TURLOCK MUNICIPAL AIRPORT
IN MERCED COUNTY, CALIFORNIA
Widen Runway 12/30 and Airfield Electrical Upgrades
FEDERAL PROJECT: AIP 03-06-0265-12-2017

Date: 8/09/2017

City Project No.: 16-75

Addendum No.: 1

| VERIFY SCALE BAR IS 1" ON ORIGINAL DRAWING 0 1/4" 3/4" 1" IF NOT ONE INCH ON THIS SHEET, ADJUST SCALES ACCORDINGLY | DRAWN BY: WEH/RSC REV. BY: DCS CH. BY: MTK DATE: JUNE 16, 2017 SCALE: AS NOTED 204-C302X.dwg | SHEET 26 OF 48 |

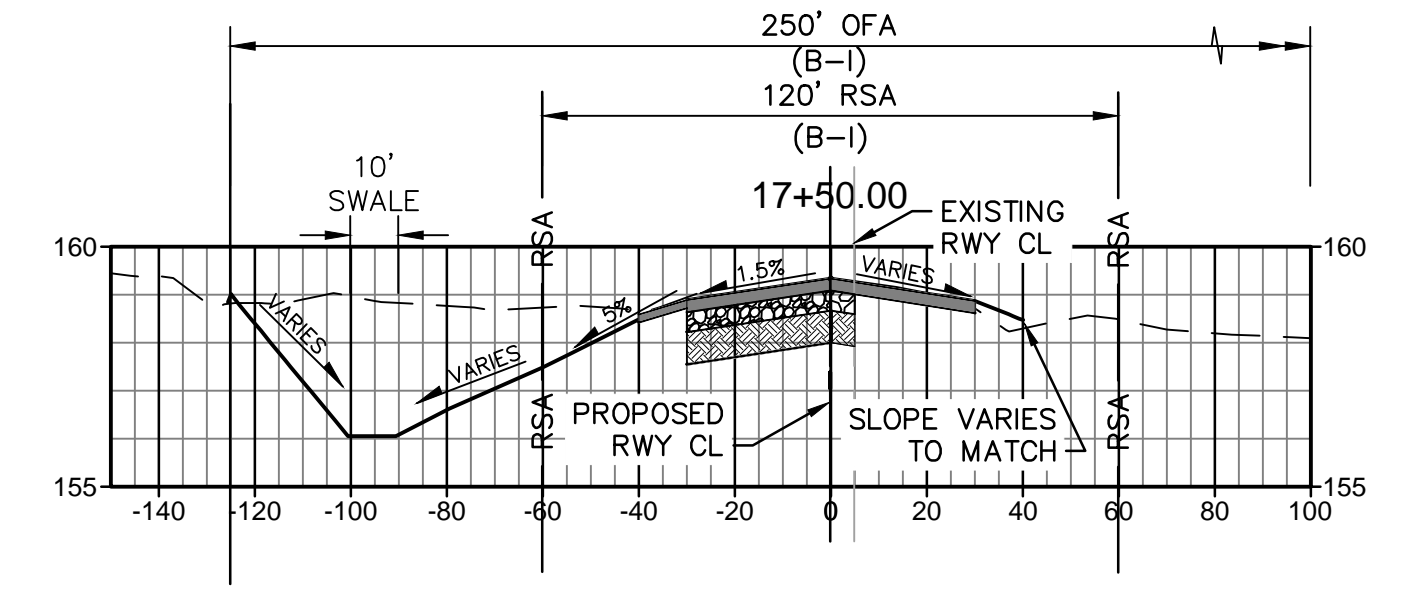
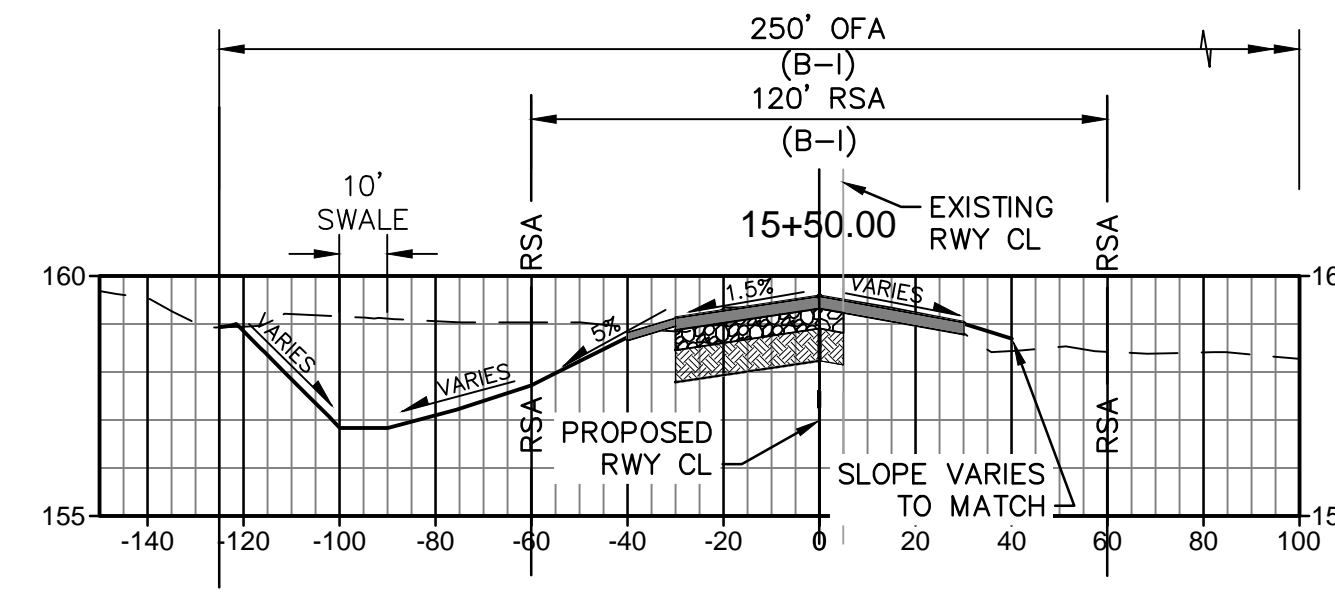
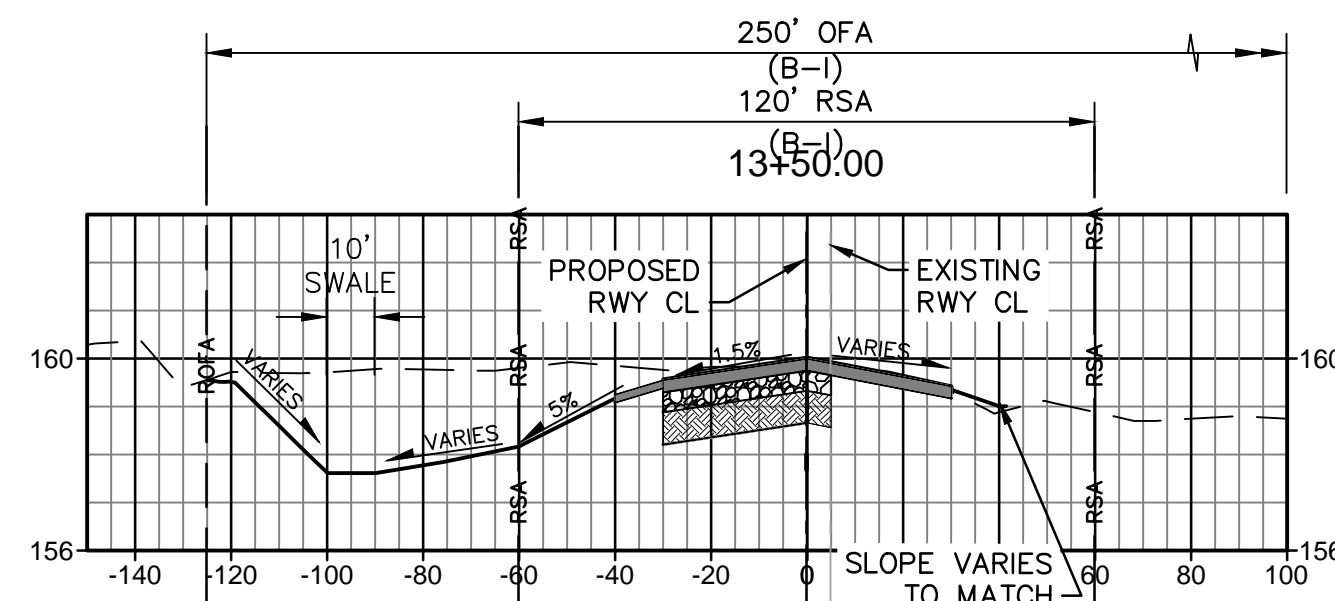
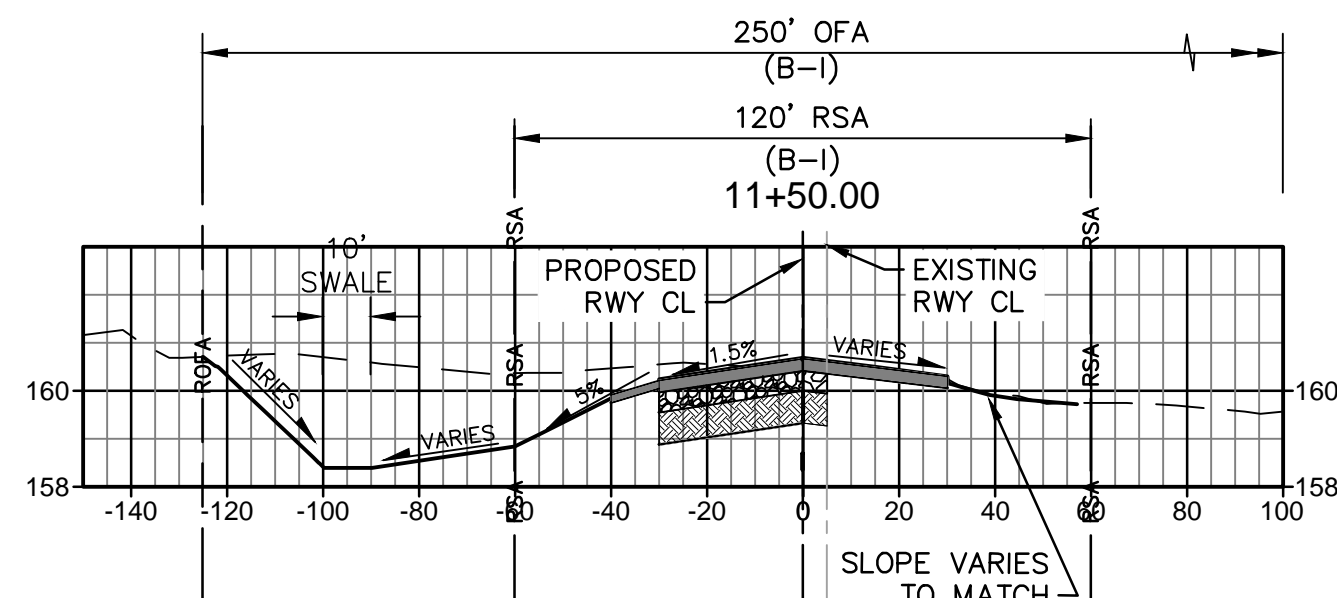
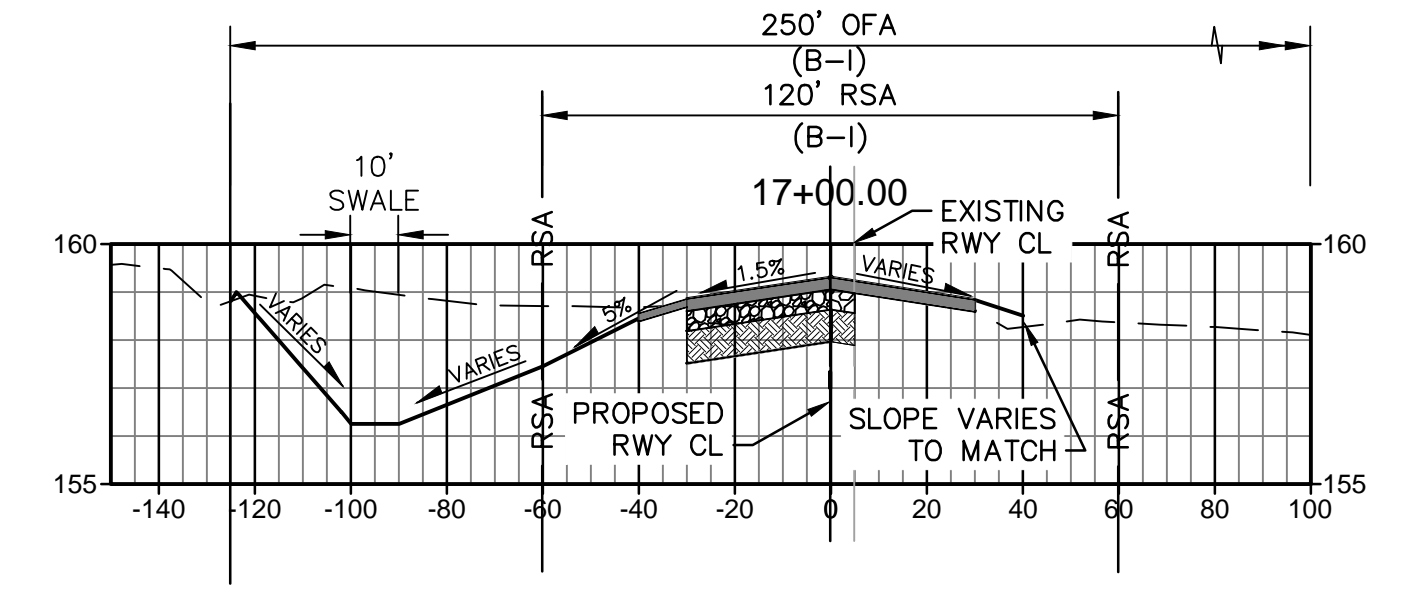
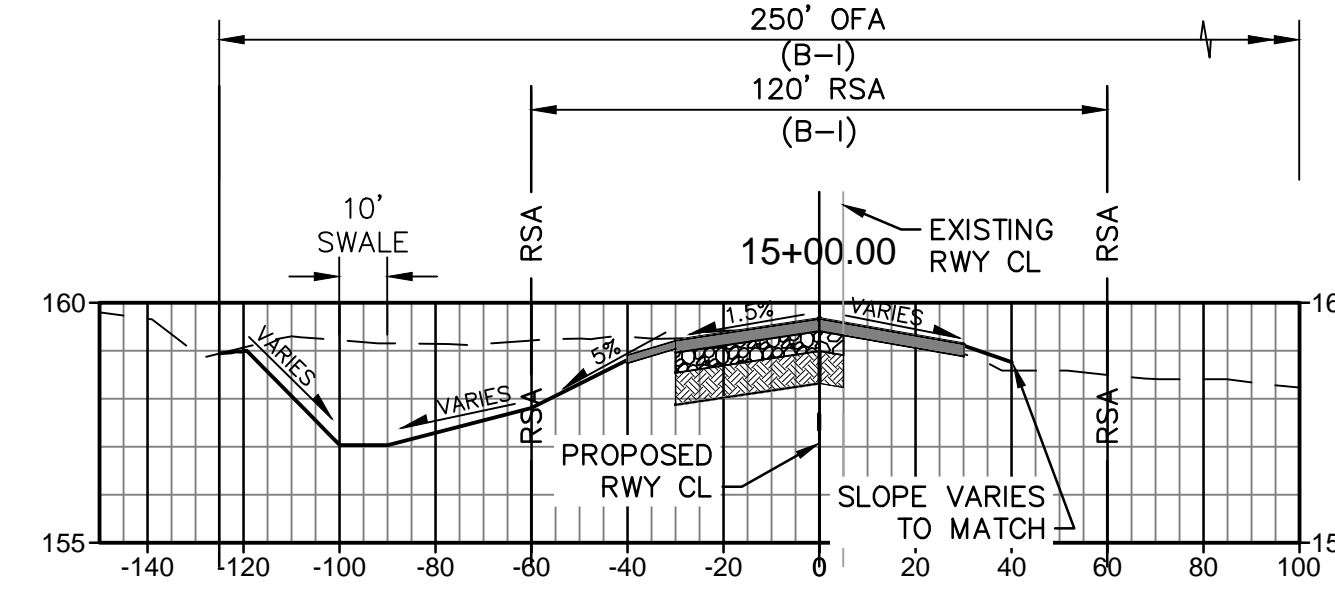
- VI. Replace sheets 26, 27, 28, and 29 with the attached sheets. Cross section station labels have been added to section locations.
